Project	<b>IEEE 802.16 Broadband Wireless Access Working Group</b> < <a href="http://ieee802.org/16">http://ieee802.org/16</a> >	
Title	<b>Extension of OFDMA Physical layer mode to support 256 &amp; 1024 point QAM constellations for high capacity back-haul applications</b>	
Date Submitted	<b>2013-03-07</b>	
Source(s)	David Castelow, Andrew Logothetis and Marlon Persaud Airspan Communications Ltd Capital Point, 33 Bath Road Slough, SL1 3UF, UK	Voice: +44 1895 467281 E-mail: dcastelow at airspan.com  * <a href="http://standards.ieee.org/faqs/affiliationFAQ.html">http://standards.ieee.org/faqs/affiliationFAQ.html</a> >
Re:	IEEE 802.16-13-0032-01-Gdoc	
Abstract	Changes required to extend 802.16 OFDMA physical layer in order to support 256-QAM and 1024-QAM constellations, along with necessary extensions to the block sizes and control codes.	
Purpose	For acceptance as part of the 802.16r amendment.	
Notice	<i>This document does not represent the agreed views of the IEEE 802.16 Working Group or any of its subgroups. It represents only the views of the participants listed in the "Source(s)" field above. It is offered as a basis for discussion. It is not binding on the contributor(s), who r

Figure 8-128A. 256-QAM constellation

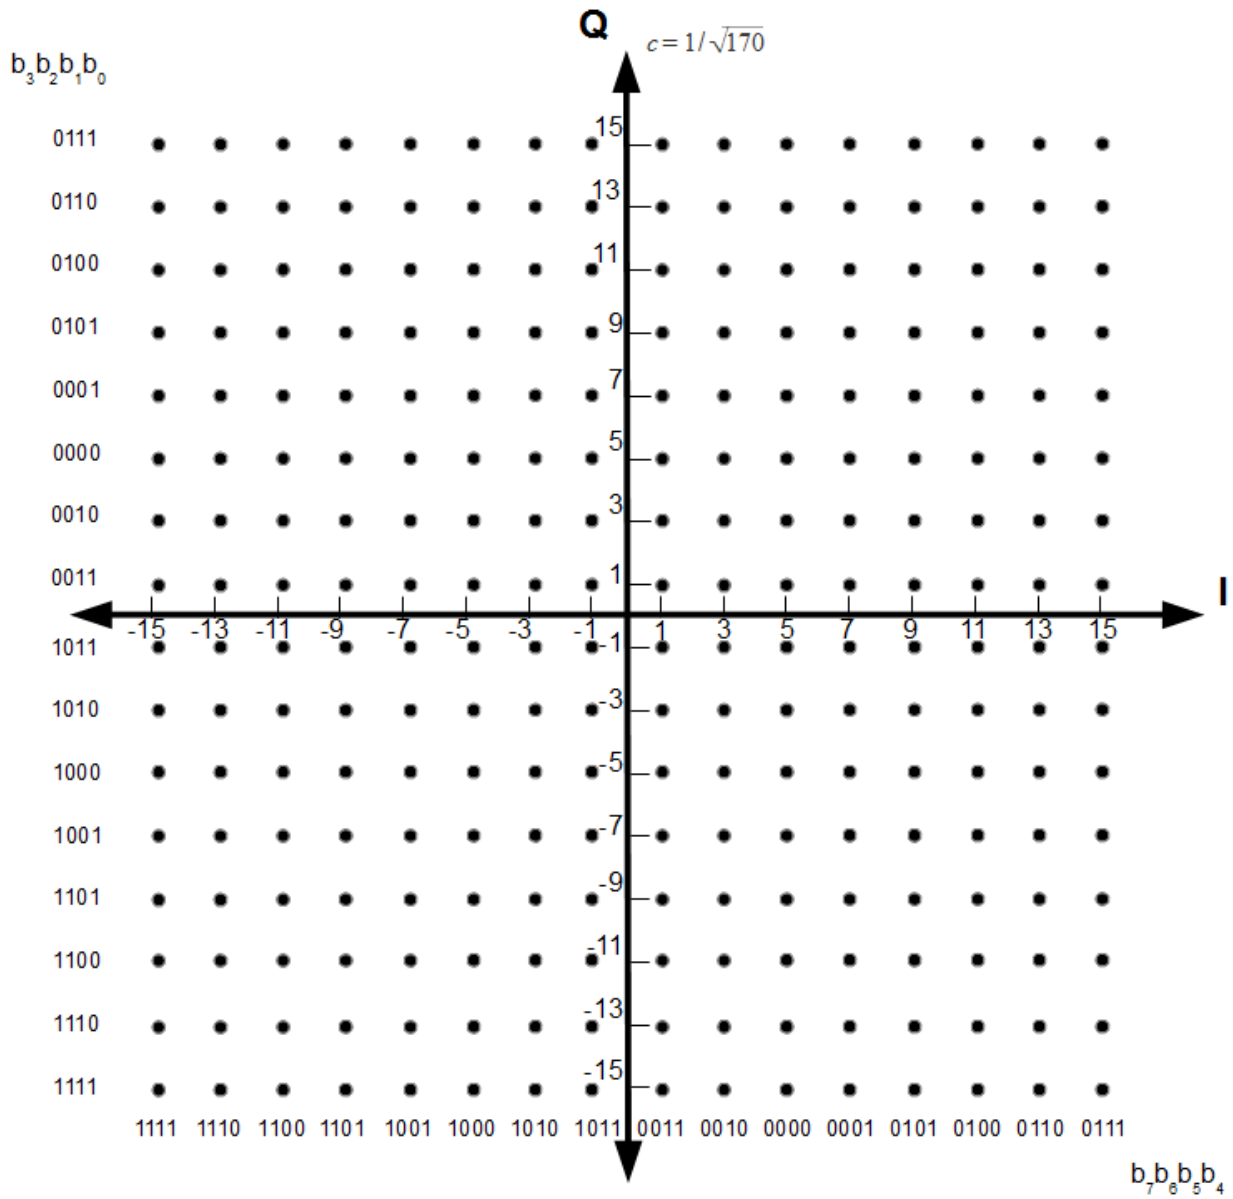
And add the following text and figures:

The Gray-mapped 256-QAM is shown in FigureFigure 8-128A The constellation shall be normalised by multiplying the constellation point by the factor  $c = 1/\sqrt{170}$  to achieve equal average power.

Figure 8-128B. 1024-QAM constellation

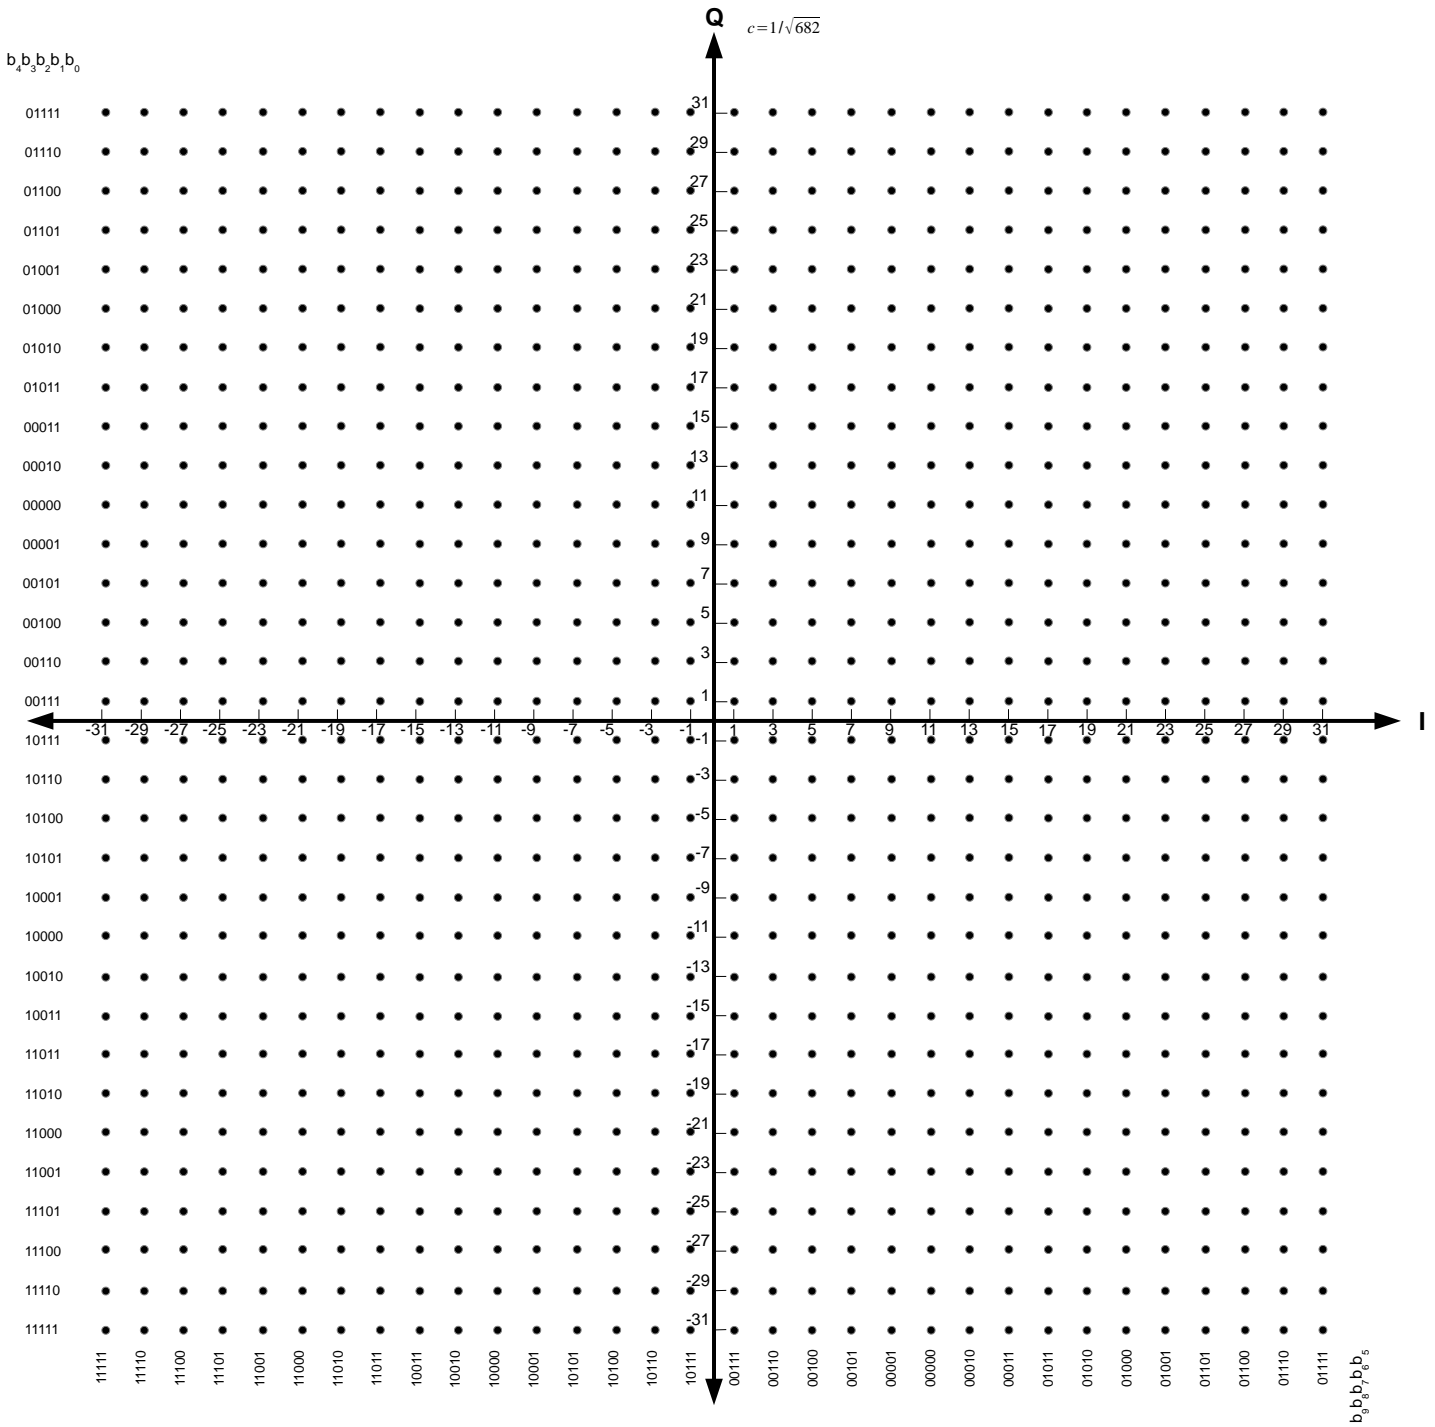
The Gray-mapped 1024-QAM is shown in Figure 8-128B. The constellation shall be normalised by multiplying the constellation point by the factor  $c = 1/\sqrt{682}$  to achieve equal average power.
